HISTORIC AND DESIGN REVIEW COMMISSION

February 21, 2024

HDRC CASE NO: 2024-063
ADDRESS: 112 E LYNWOOD
LEGAL DESCRIPTION: NCB 6383 BLK 3 LOT 61 THRU 67
ZONING: R-5, H
CITY COUNCIL DIST.: 1
DISTRICT: Monte Vista Historic District
APPLICANT: Marco A Cortes
OWNER: Michael R Goldstein
TYPE OF WORK: Carport construction
APPLICATION RECEIVED: February 2, 2024
60-DAY REVIEW: April 2, 2024
CASE MANAGER: Bryan Morales

The applicant is requesting a Certificate of Appropriateness for approval to construct an approximately 530 sqft carport.

2 PROPOSED FLOOR PLAN
1/8" = 1'-0"

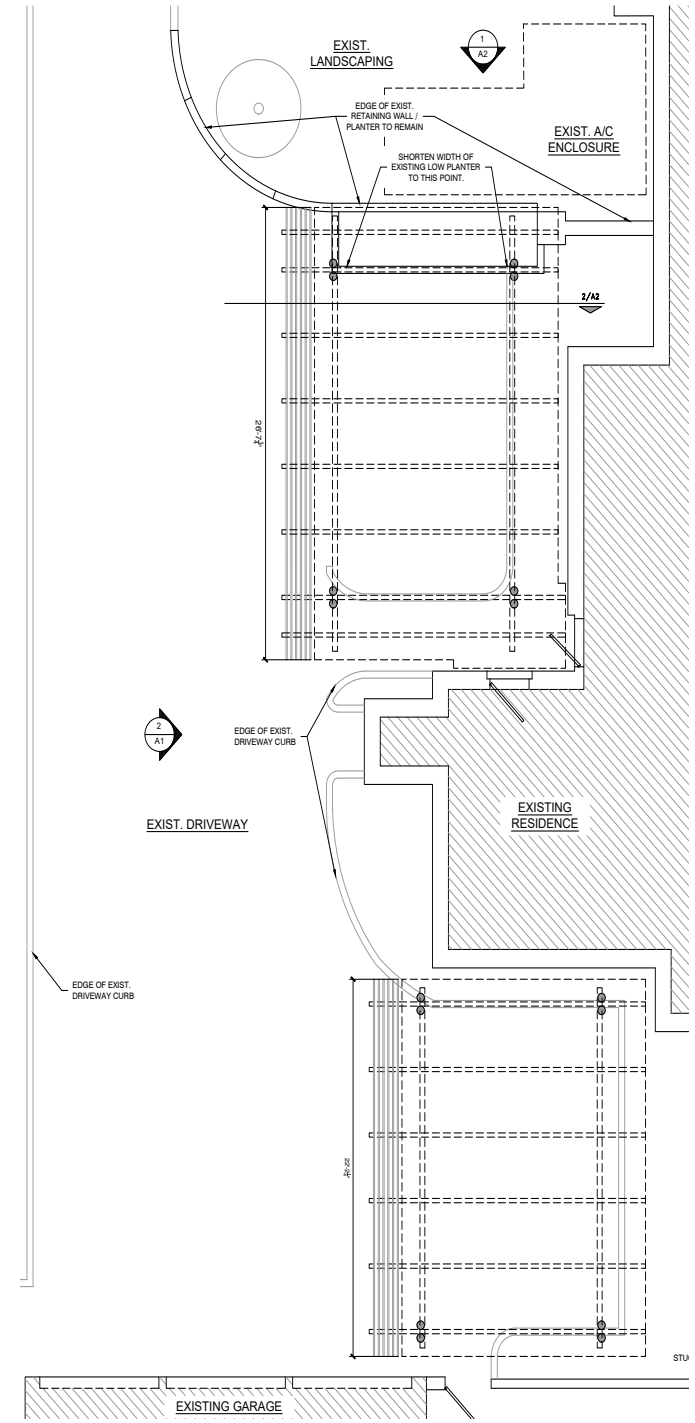
- c. **MASSING AND FORM** – The applicant is requesting to construct a carport on the west side of the property. The Historic Design Guidelines for Additions 1.A.i. states to site residential additions at the side or rear of the building whenever possible to minimize views of the addition from the public right-of-way. Additions 1.B.i. states to design residential additions to be subordinate to the principal façade of the original structure in terms of their scale and mass. Additions 1.B.v. states the height of new additions should be consistent with the height of the existing structure and that the height should never be so contrasting as to overwhelm or distract from the existing structure. Staff finds the side carport on the western façade of the primary structure generally appropriate.

- d. **ARCHITECTURAL FEATURES** – The proposed carport features steel-tube columns and a flat roof form. Additions 4.A.ii. states to incorporate architectural details that are in keeping with the architectural style of the original structure, details should be simple in design and compliment the character of the original structure, and that architectural details that are more ornate or elaborate than those found on the original structure should not be used to avoid drawing undue attention to the addition. Staff finds the proposed architectural features of the proposed carport generally appropriate.

- e. **ROOF** – The applicant is requesting to install a flat TPO roof on the proposed carport. The Historic Design Guidelines for Exterior Maintenance and Alterations 3.B.v. allows the use of contemporary roofing materials on flat or gently sloping roofs not visible from the public right-of-way. Additions 3.A.i. states to use materials that match in type, color, and texture and include an offset or reveal to distinguish the addition from the historic structure whenever possible and that any new materials introduced to the site as a result of an addition must be compatible with the architectural style and materials of the original structure. Staff finds the installation of a non-visible flat TPO roof generally appropriate.

- f. **MATERIALS** – The applicant is requesting approval to construct a carport on the western façade of the primary structure to feature steel-tube columns. Additions 3.A.i. states to use materials that match in type, color, and texture and include an offset or reveal to distinguish the addition from the historic structure whenever possible and that any new materials introduced to the site as a result of an addition must be compatible with the architectural style and materials of the original structure. Staff finds the proposed materials generally appropriate.

- i. The steel members be painted to match the existing natural tones and colors found on site.
- ii. That the applicant meet all setback standards as required by city zoning requirements and obtain a variance from the Board of Adjustment if applicable.
